# Commonwealth Edison Company

December 7, 1970

On October 27, 1970 you forwarded comments by the Department of Health, Education, and Welfare concerning our environmental report for the Dresden Nuclear Power Station Unit 3. You asked for responses to items 1, 2 and 4 of these comments. Enclosed are our responses to those items.

FIGURE I-1

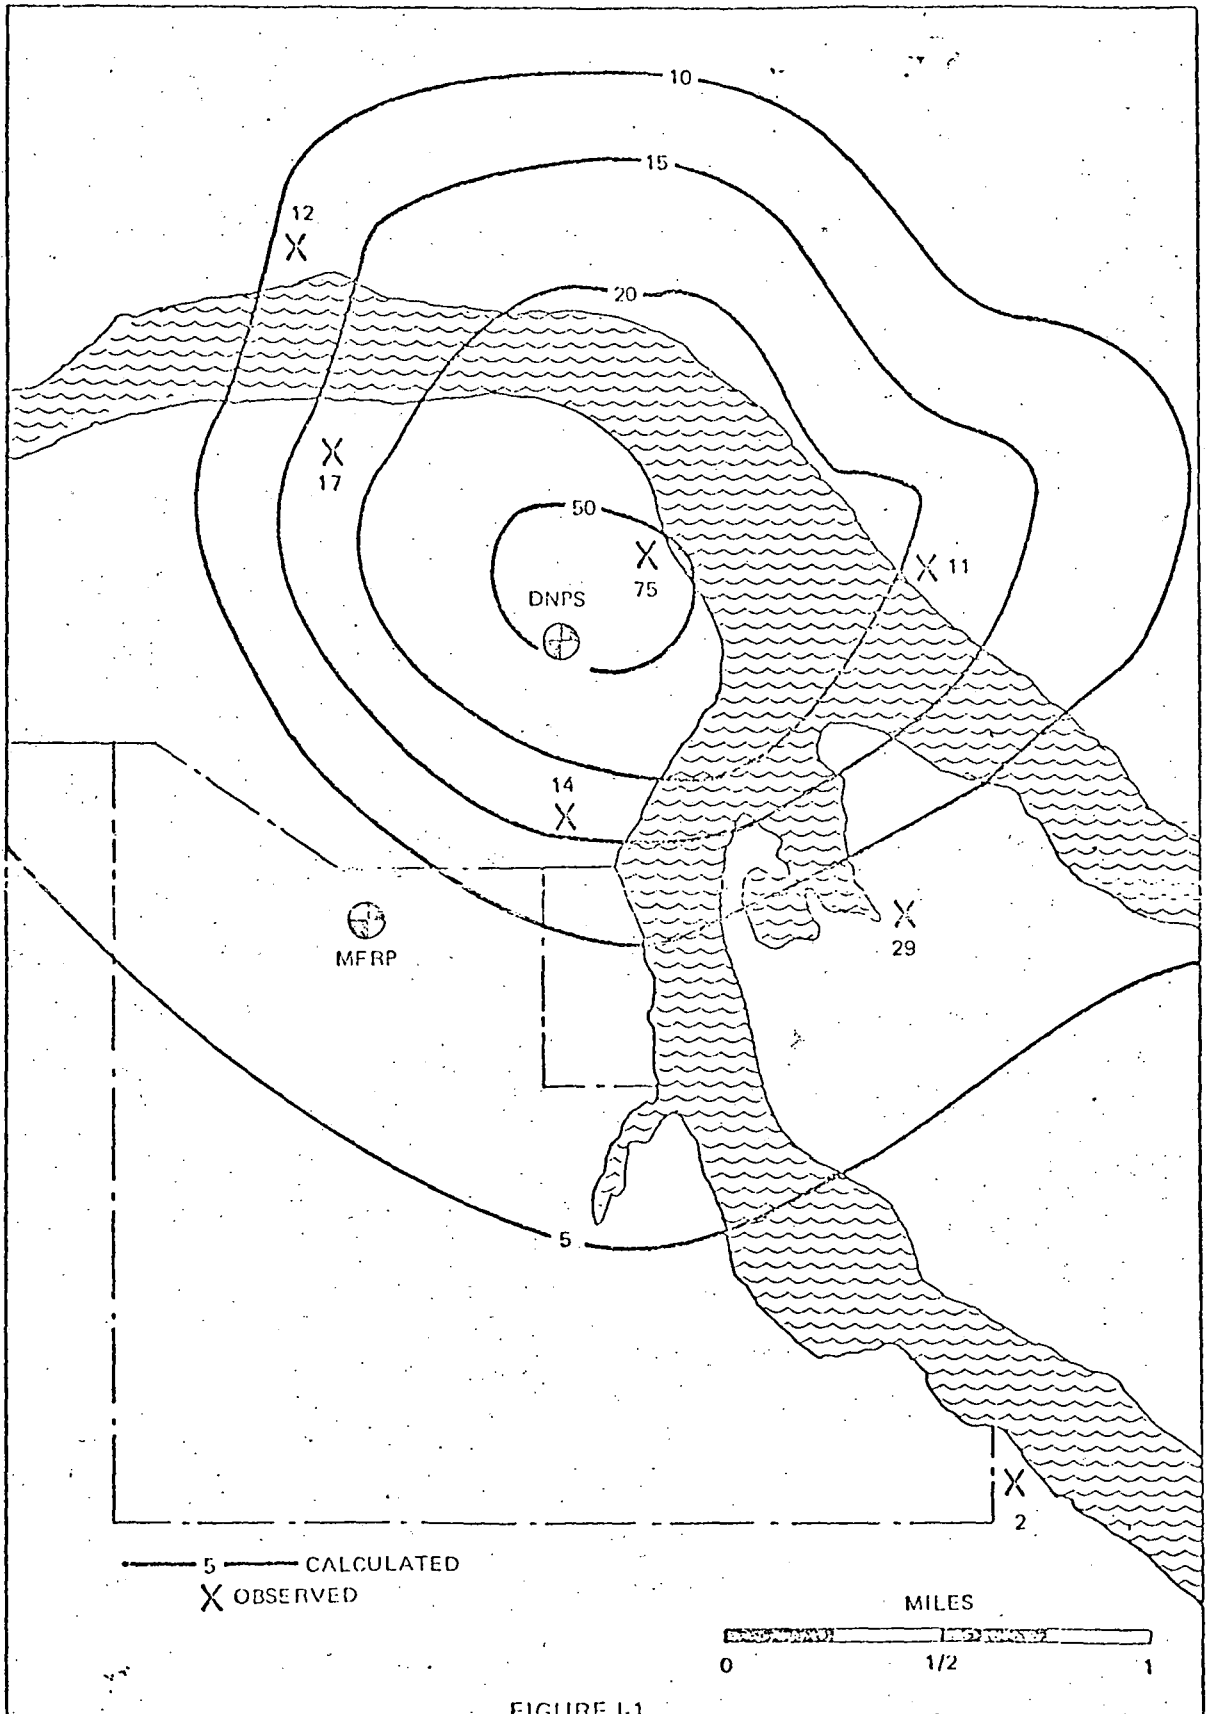
The only presentation of estimated offsite radiation dose is for facility operation without any leaking fuel elements. The operating histories of boiling water reactors (BWR) have shown leaking fuel elements usually exist during normal operation. Therefore, the applicant should estimate, based on discharge data obtained from operating BWR power plants, the potential population dose from the combined operation of the three Dresden units for this condition.

In the case of the Dresden site, data were used for a period where off-gas release was just measurable in the environment. The values used in these determinations were obtained from paired 10-mr gamma dosimeters in each of the environmental stations at Dresden. All chambers were read weekly with results averaged on a monthly basis. The calculated iso-dose contours relating doses in the environment to Dresden Unit 1 stack emission were compared to the field data. A seven-month period when the release rate averaged about 51,500  $\mu$ Ci/sec (September 1964 to March 1965) was selected as the test period. Since the high environmental background resulting from atmospheric bomb testing was known to be decreasing during the period of interest, comparable seven-month periods the year before and the year following the period of interest were averaged to minimize seasonal meteorological variables. The background obtained was subtracted from the gross reading during the period of test. Results were compared to predicted values obtained from iso-dose curves obtained for a release

rate of 51,500  $\mu$ Ci/sec. Statistical analysis has shown that the ion chambers lowest level of detection at the 05% confidence level was approximately 0.4 to 0.5 mr/wk above background. Results of these comparisons are shown in Figure 1-1. In this case, the measurements are quite near the sensitivity of the instruments so that more uncertainty exists in the data compared with Brookhaven data. However, agreement between predicted and observed data is still quite good with predicted maximum dose being greater than observed except for one instance.

FIGURE I-1

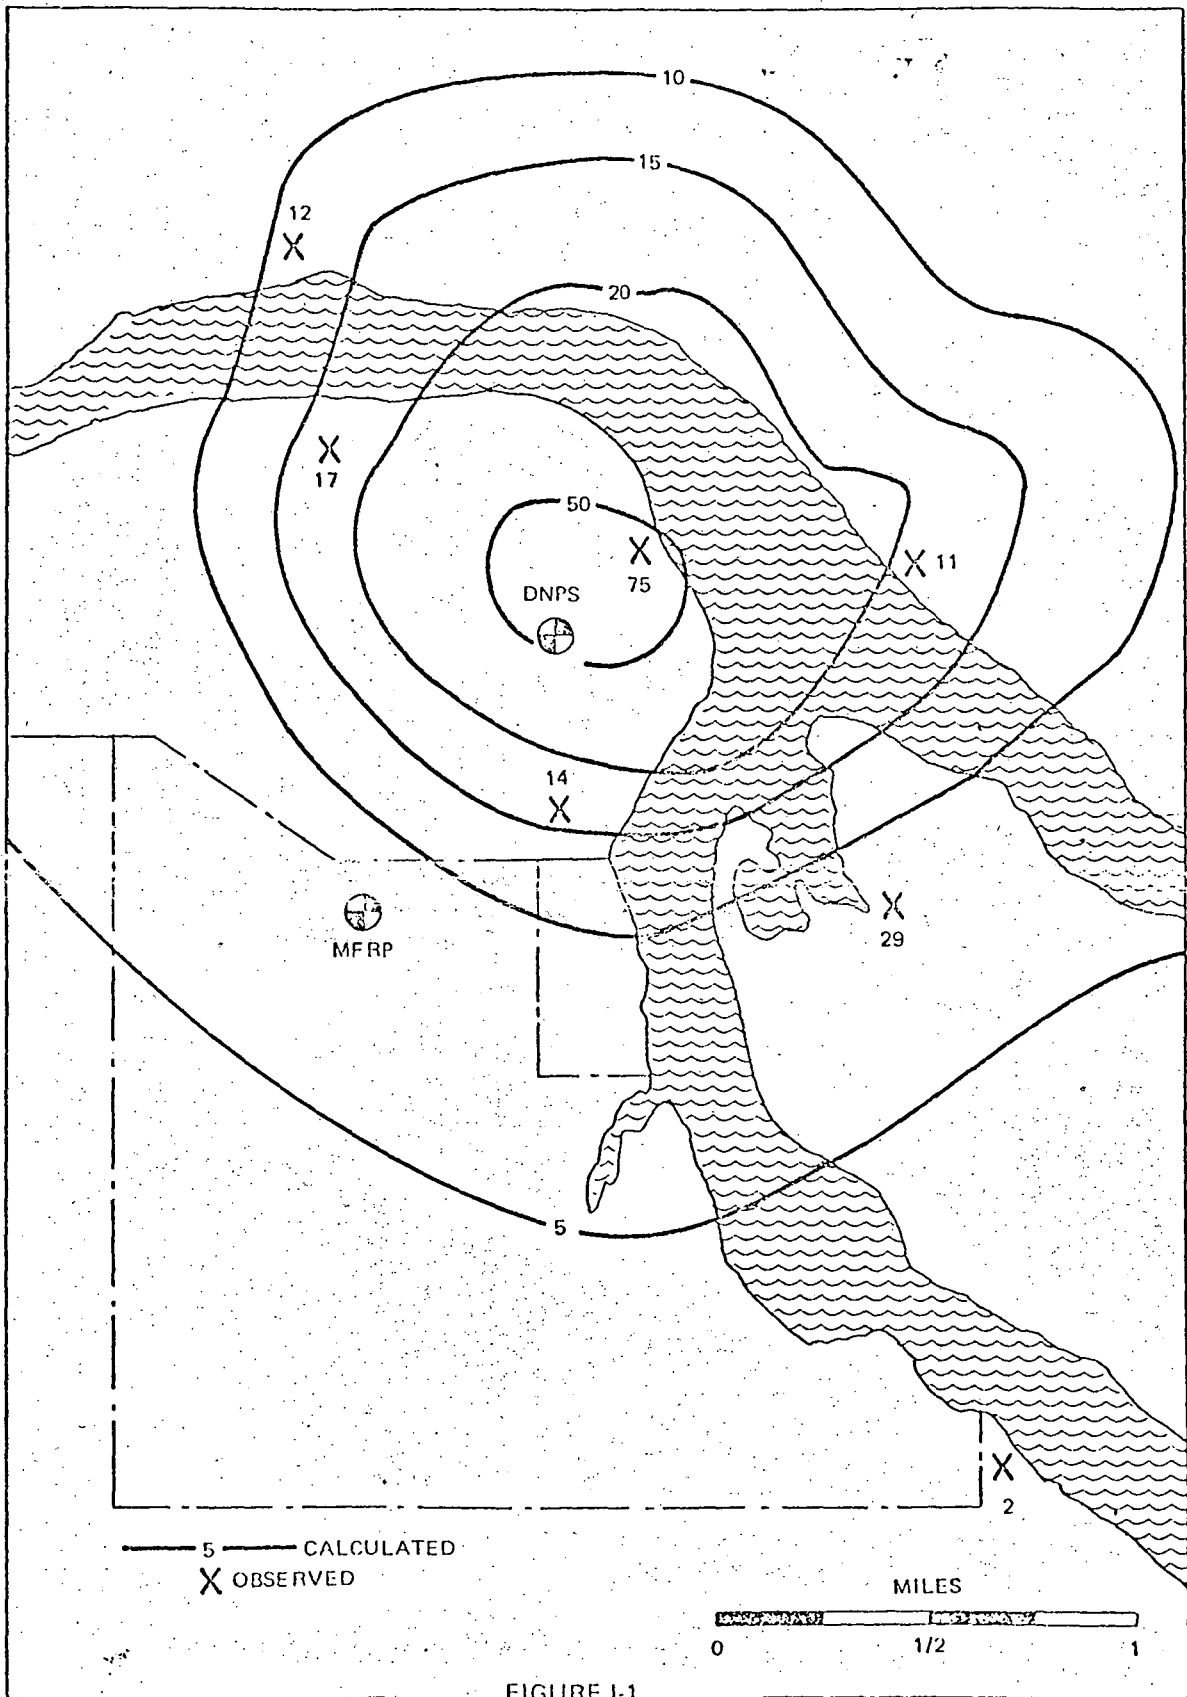
The only presentation of estimated offsite radiation dose is for facility operation without any leaking fuel elements. The operating histories of boiling water reactors (BWR) have shown leaking fuel elements usually exist during normal operation. Therefore, the applicant should estimate, based on discharge data obtained from operating BWR power plants, the potential population dose from the combined operation of the three Dresden units for this condition.

In the case of the Dresden site, data were used for a period where off-gas release was just measurable in the environment. The values used in these determinations were obtained from paired 10-mr gamma dosimeters in each of the environmental stations at Dresden. All chambers were read weekly with results averaged on a monthly basis. The calculated iso-dose contours relating doses in the environment to Dresden Unit 1 stack emission were compared to the field data. A seven-month period when the release rate averaged about 51,500  $\mu$ Ci/sec (September 1964 to March 1965) was selected as the test period. Since the high environmental background resulting from atmospheric bomb testing was known to be decreasing during the period of interest, comparable seven-month periods the year before and the year following the period of interest were averaged to minimize seasonal meteorological variables. The background obtained was subtracted from the gross reading during the period of test. Results were compared to predicted values obtained from iso-dose curves obtained for a release

rate of 51,500  $\mu$ Ci/sec. Statistical analysis has shown that the ion chambers lowest level of detection at the 05% confidence level was approximately 0.4 to 0.5 mr/wk above background. Results of these comparisons are shown in Figure 1-1. In this case, the measurements are quite near the sensitivity of the instruments so that more uncertainty exists in the data compared with Brookhaven data. However, agreement between predicted and observed data is still quite good with predicted maximum dose being greater than observed except for one instance.
